PCI Design Handbook

Precast and Prestressed Concrete, Sixth Edition

In 2004, the Precast/Prestressed Concrete Institute published the sixth edition of the PCI Design Handbook—Precast and Prestressed Concrete (MNL-120-04). Although careful efforts were made to provide an accurate document, some errors have been discovered. We suggest that you mark your sixth edition to reflect these errata so that use of the handbook is accurate.

EXAMPLE 6.14.1

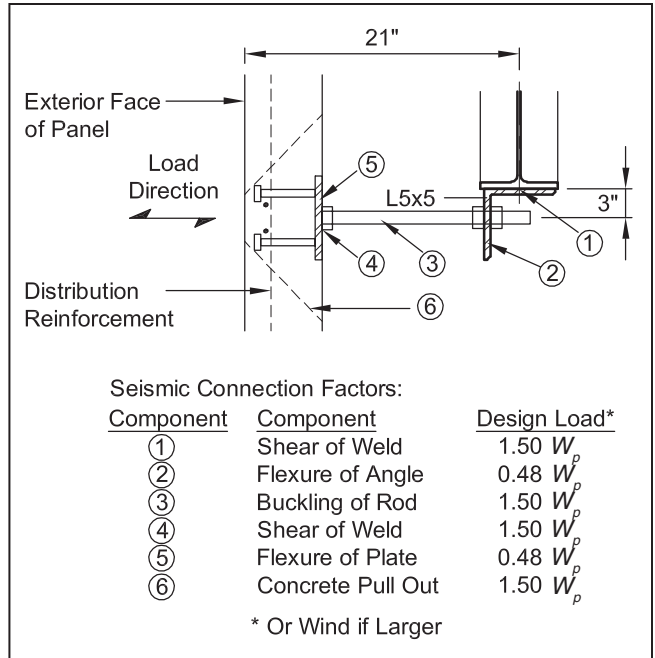
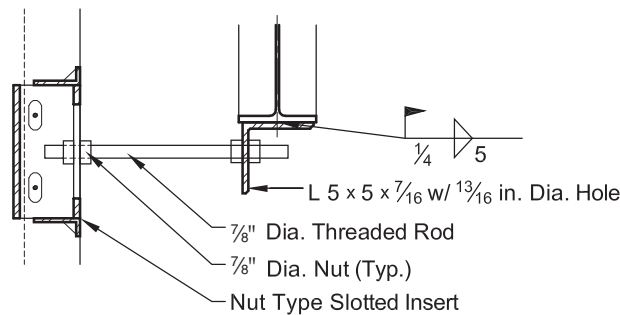
57. Page 6-56: In the right column, fourth line, change the formula to read “0.5V_u/(0.85f_cb)”.
58. Page 6-72: In Example 6.14.1 uses forces determined in Example 3.2.4.2. The seismic force of 3368# already included (in Example 6.14.1) the “0.48W_p” multiplier; therefore, the calculated values presented in the table under the heading “Seismic Design Load” are incorrect. The “5.05 kips” force should be “10.52 kips” and the “1.62 kips” force should be “3.368 kips”. See Appendix B of this document indicates the revisions to the affected values.

Cladding Connections — Reference Examples 3.2.3.1 and 3.2.4.2

Given:

Cladding tension-compression tieback connection of Examples 3.2.3.1 and 3.2.4.2.

Loads—from “Summary of Factored Loads to Connections (lb)” Example 3.2.4.2:

Seismic: 3368 lb (in or out). Based on $0.48 W_p$.
 Wind: 4184 lb (out)
 Concrete: $f'_c = 5000$ psi
 Steel: $F_y = 36$ ksi; $F_u = 58$ ksi
 Weld: E70

Apply connection factors (seismic only) shown at right:

From example 3.2.4.2:

$$0.48 W_p = 3.368 \text{ kip}$$

$$1.5W_p = \frac{1.5}{0.48}(3.368) = 10.52 \text{ kip}$$

$$\text{Factored wind load: } \frac{4184}{1000} = 4.18 \text{ kip}$$
